Discussion items

SVD mechanics session

Space requirement from QCS

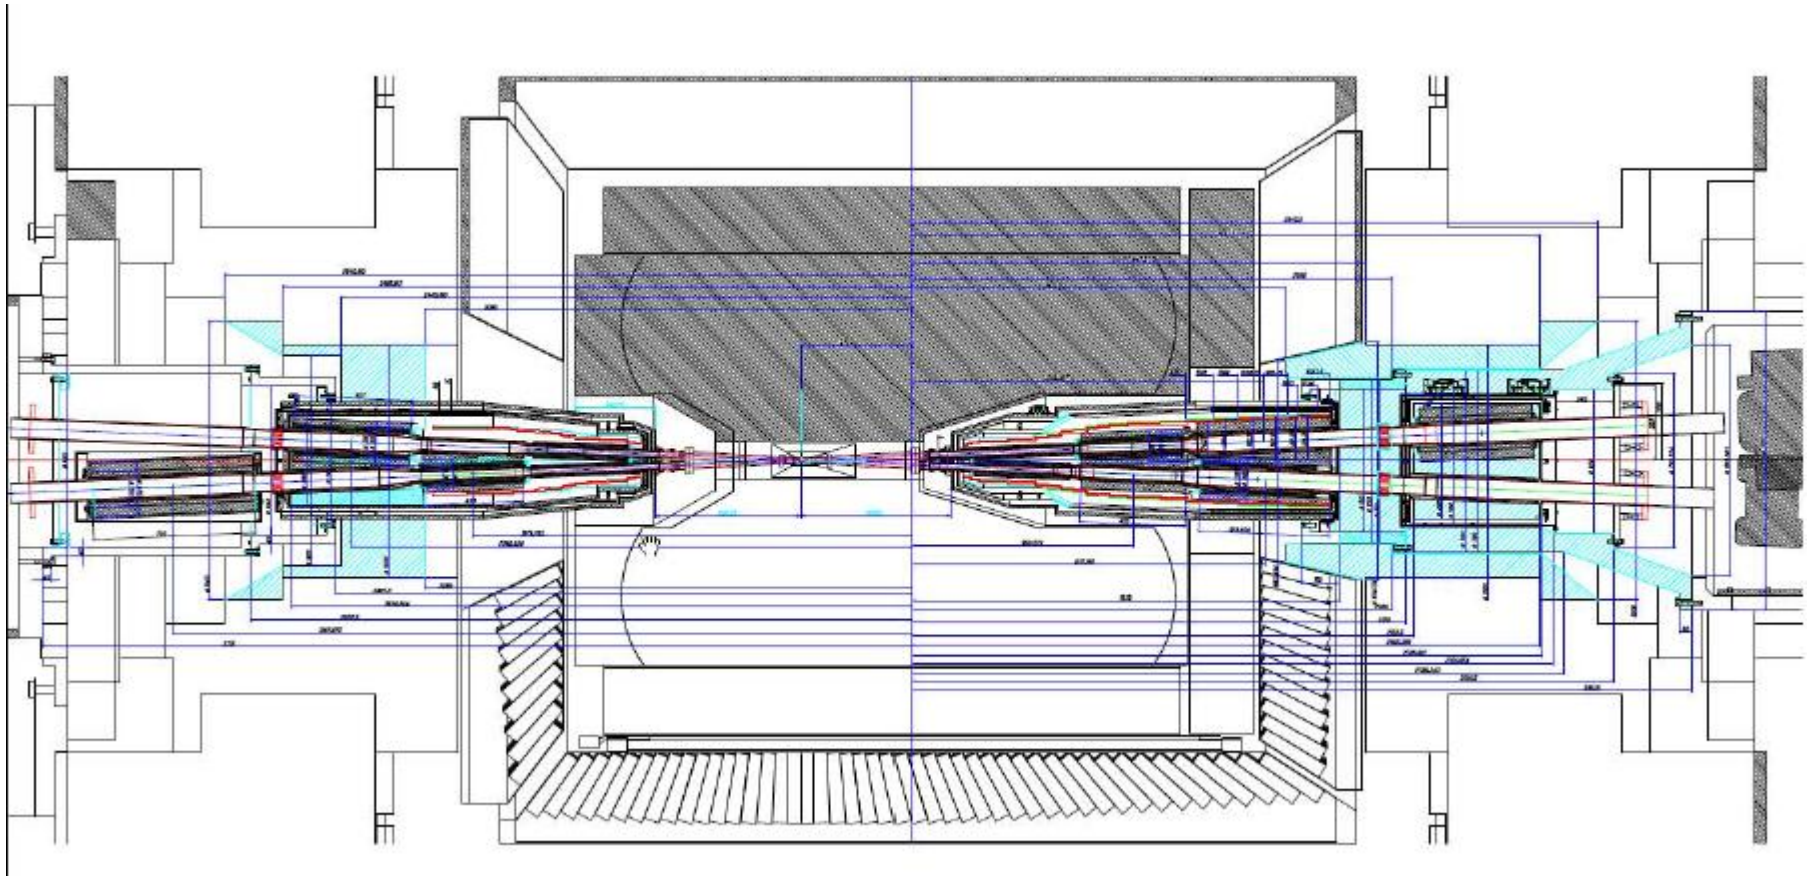
- Ouchi-san (QCS group leader) propose to put iron shield between QCS and Belle structure (Blue region)

PXD/SVD dock space seems to be still free for this requirement

The impact on beam lifetime

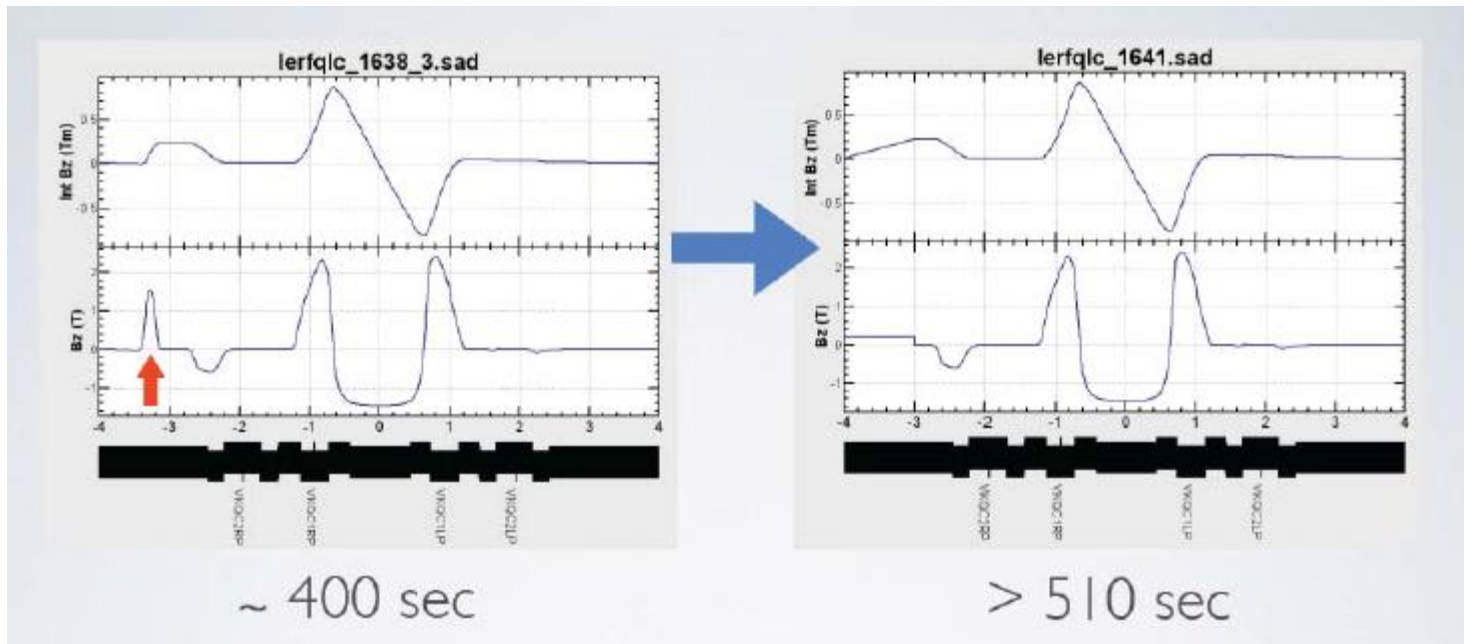
- With 3D magnetic field calculation, we realized the bump (red arrow) of Bz causes shorter Touscheck lifetime.
- In order to reduce this effect, the space between QCS cryostat and Belle structure should be fulfilled by iron structure.

- We have to summarize the space requirement of cables and piping which placed along QCS structure(blue region) **before this end of March**, because QCS design have to freeze before starting production.
 - I want to discuss on next SVD/PXD meeting about this subject ,after then we will make a report of space requirement at next B2GM.
- Of course, we require that Endcap structure can move to maintenance position easily.
- **Now KEKB group changed their policy not to fill iron because of huge electromagnetic power on QCS quench(60tons). (Optics group can manage to control without iron**
- **Whatever we should update our list for services.**

Conflict region(koike+tsuboyama)

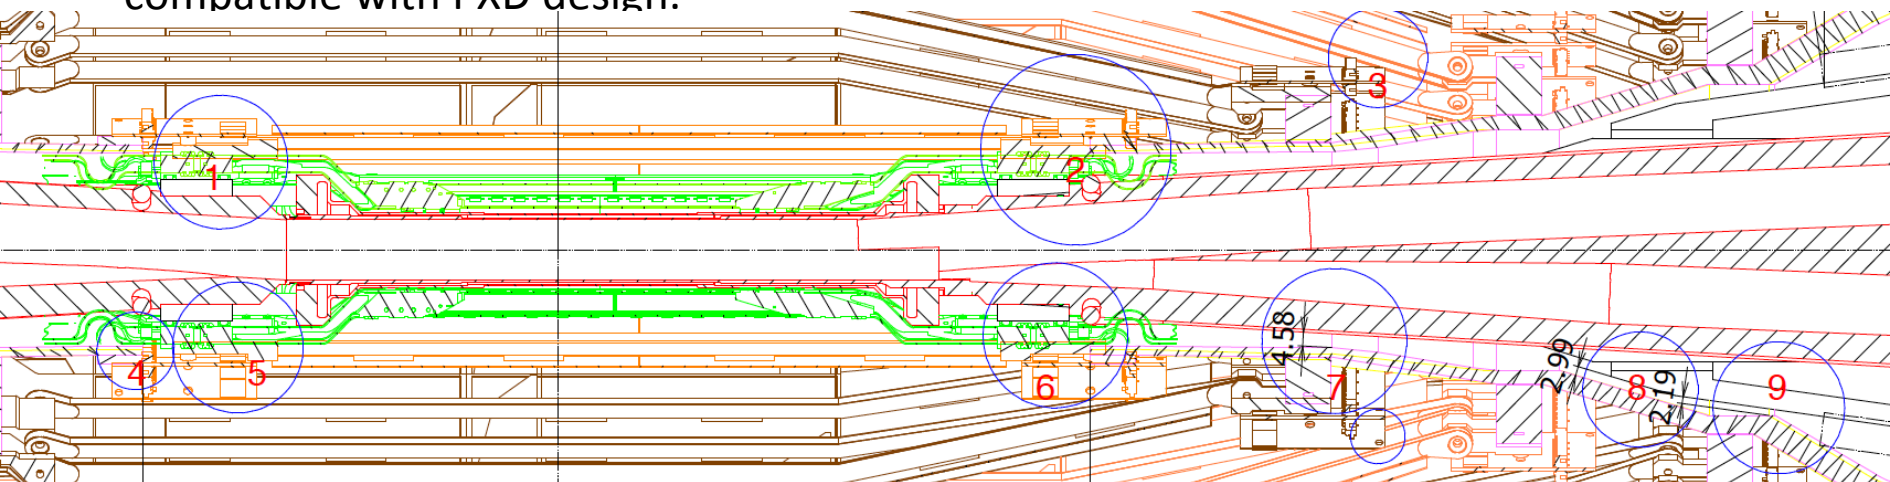
- The structure is cut at the center and a projection is made.
 - Hatched region is the cut surface.

- Rib shape, connectors and Hybrid size, cooling and their contact
- (need more discussion or more test or only design problem !?)
- Why don't to create task force?
-

- 7-9: The CFRP shape has been changed. The previous shape (shown in yellow) was compatible with PXD design.

- More discussion with PXD and SVD will be very helpful to remove interference.
- The STEP file shows 8 ladders in L3 and there are interferences. It is not clear “8 ladders in L3” is proposed or not.

- It looks the Z position is defined in the backward support ring and mount block. However, it is not clear where/how the origin of ladders are defined.

- The border between SVD and PXD should be defined immediately. Otherwise the shapes of CFRP cone, support rings can not be designed.
 - Done in next week, when PXD and SVD designers meet face to face in Vienna.
